8th Edition (2023) Florida Building Code

ICC 2021 Code Changes

TAC: Accessibility

Total Mods for **Accessibility** in **Denied – Consent**: 42

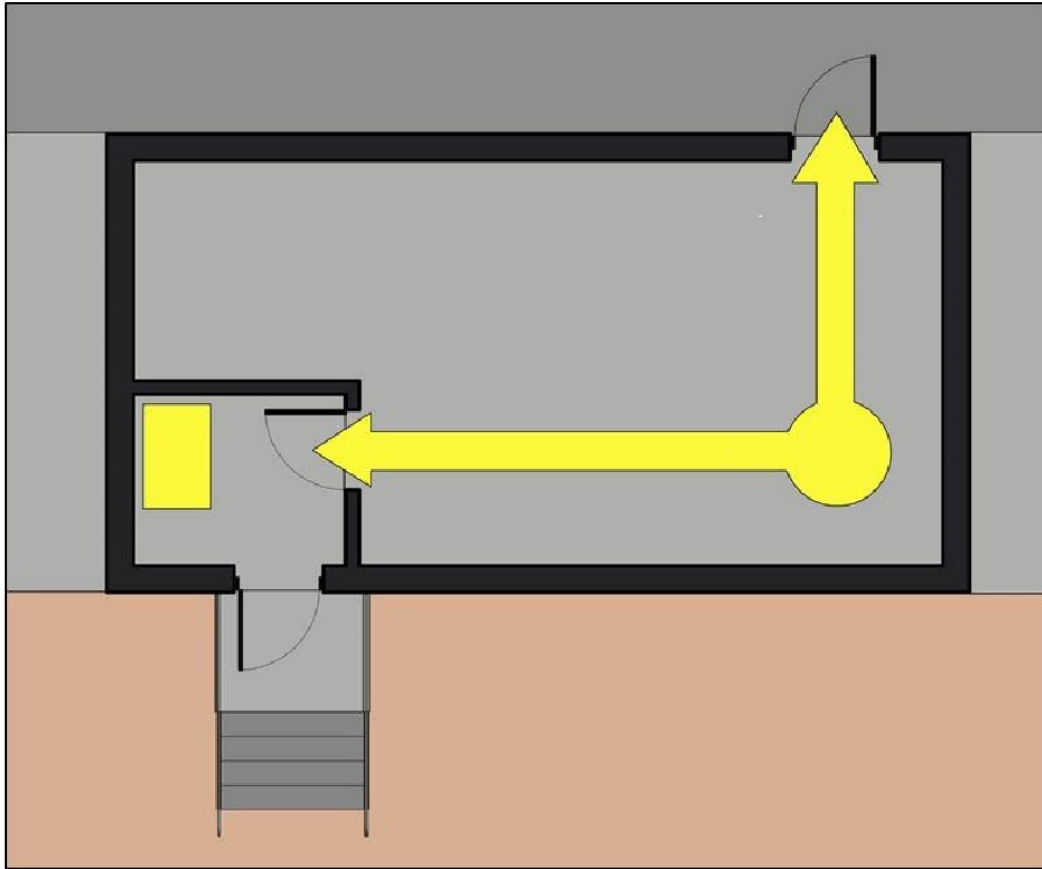
Currently the text does not address an area of refuge in a single story building at the second exit. It only addresses areas of refuge on upper floors. The proposed text fixes that technical glitch.

The image below represents what this proposed code change is attempting to allow, an interior area of refuge with direct access to the exterior of the building.

ASSISTED BATHING
ROLL-IN SHOWER -
USING EXCEPTIONS
EXAMPLE 1

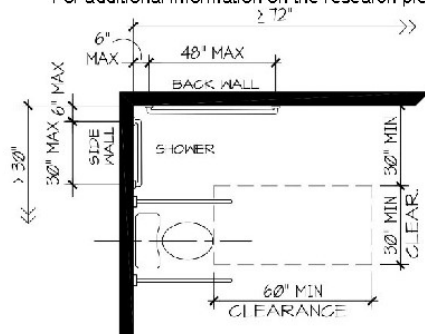
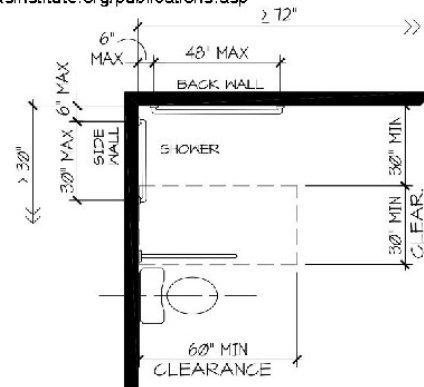
The key part of this change is to remove the requirement for permanently installed folding or fixed seats. These wall-mounted seats do not work well when residents are being assisted with showering. The wall mounted seats make it challenging for care-givers to access the back and one side of the resident they are bathing. Most often, if residents cannot stand for bathing, a portable, rolling chair is used and the folding seat stays folded up (but takes up space). This allows the care-giver greater access to all sides of the resident. In addition, the rolling chair is often easier to transfer to for older adults, than a wall mounted seat.

This proposal also recognizes alternate shower configurations that provide equal, if not better accessibility. For example, many nursing homes provide a "European" shower where two sides are open to the bathroom. This provides greater access for both resident with mobility issues as well as the care-giver. Water can be managed with shower curtains, either on a curtain track or an "L-shaped" curtain rod, however usually the entire room is designed to be a "wet room".
